NEW PRODUCT RELEASE

VAL-CO Adds Control Tubes to Floor Feeding Lines for Better Feed Distribution!

Floor Feeding Control Tubes

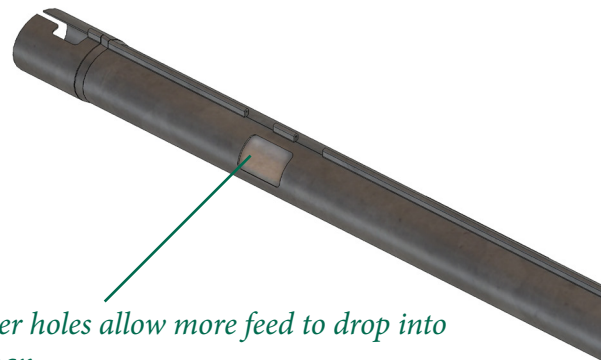
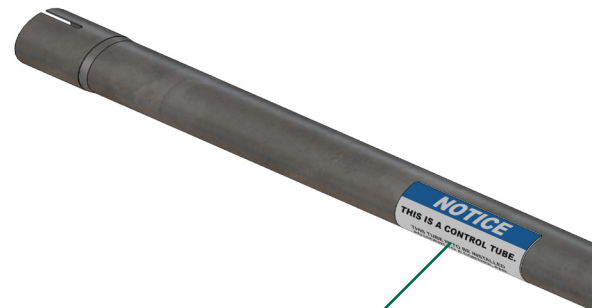
The new floor feeding control tubes have larger drop holes to allow more feed into the pans preceding a mid- or end-line control pan.

These larger holes decrease feed bypass to ensure all feeders prior to the control pan fill quickly and completely. This ensures birds do not migrate away from the control pan.

The control tubes are labeled with a sticker so that they may be easily differentiated from standard tubes.

Larger holes allow more feed to drop into the pan.

Labels on the tube for easy identification.
